City Horn
VHD, VAH

FSB 362-001, City Horn

(February 2014)

W3000569

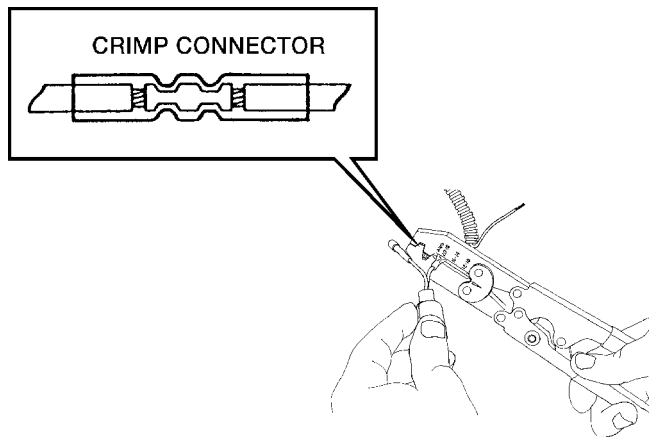
- 6 Strip each wire of the chassis harness evenly approximately 8mm (0.314 in).

W3002876

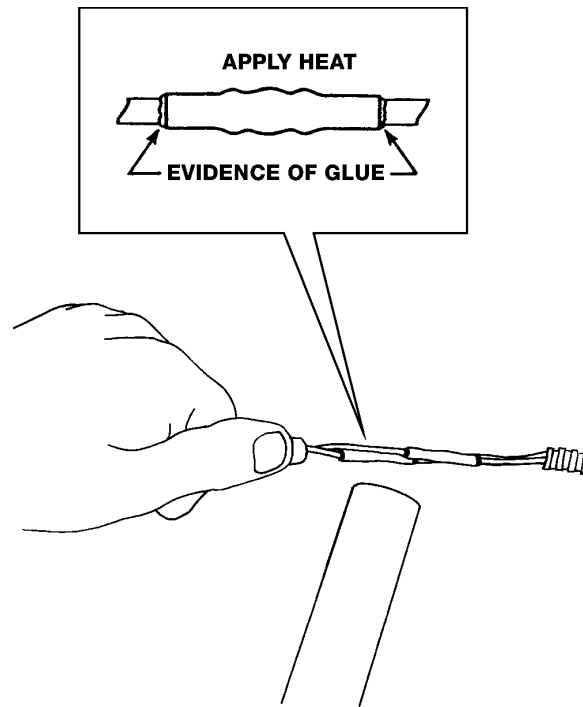
- 7 Crimp the splice leads from the new pigtail harness (22285544) to the chassis wires.

Note: Match the new connector wires to the harness in the same position as before.

W3002877

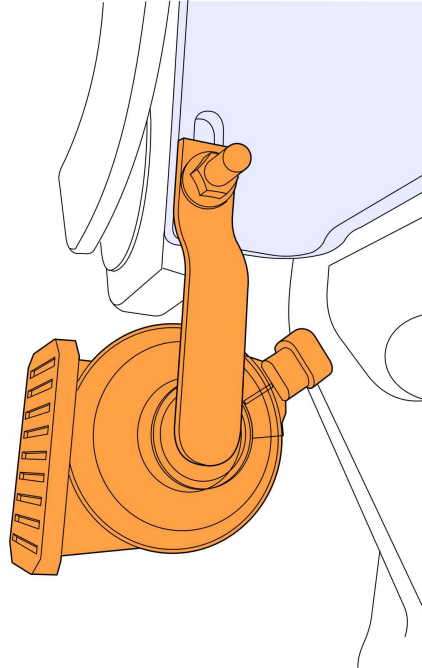
- 8 Heat shrink the wire splices properly using a heat gun.

Note: Heat shrink the splices until the glue appears from the end of splice.

Note: Make certain the factory crimped ends of the splice are also heat shrunk properly.
